Memorandum

Re: Lincoln Hall: Floor site walk

On October 22, 2025, members from Studio GC and Lincolnwood School District 74 conducted a walkthrough at Lincoln Hall School to review the soft floor spots observed by District personnel in various classrooms. Below is a summary of our observations.

Image 1 - 2nd floor Lincoln Hall

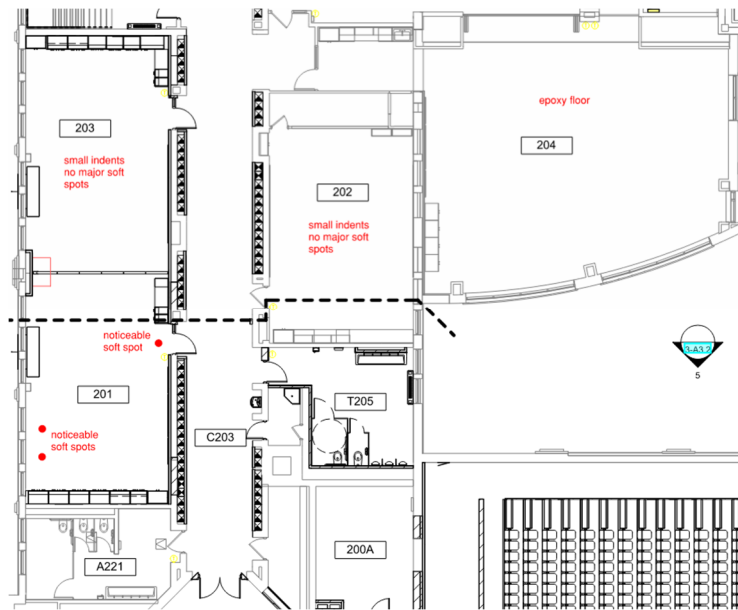
The existing drawings from the 1940 building indicate a gypsum concrete over wood joists floor construction. While no structural concerns are evident, over time with the bending and shifting of the floor under load, the gypsum concrete is susceptible to cracking due to its inelasticity. The soft spots observed during our walkthrough were on the 2nd and 3rd floors. No spots were observed on the 1st floor.

Image 3

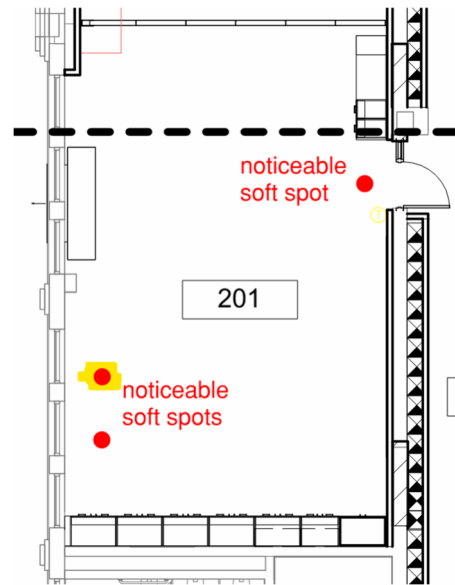
When the carpet tile floor finish was pulled back on one of the spots on the 2nd floor, in Image 3 below, this spot was noted to have telegraphed through the full depth of the floor. It is recommended to repair and improve this floor slab condition by cutting back and removing the gypsum concrete floor slab between the wood joists and as wide as the nearest non-

flaking/cracking gypsum and infilling the removed area with additional wood framing supports below, plywood and a leveler to meet the elevation of the existing floor finish.
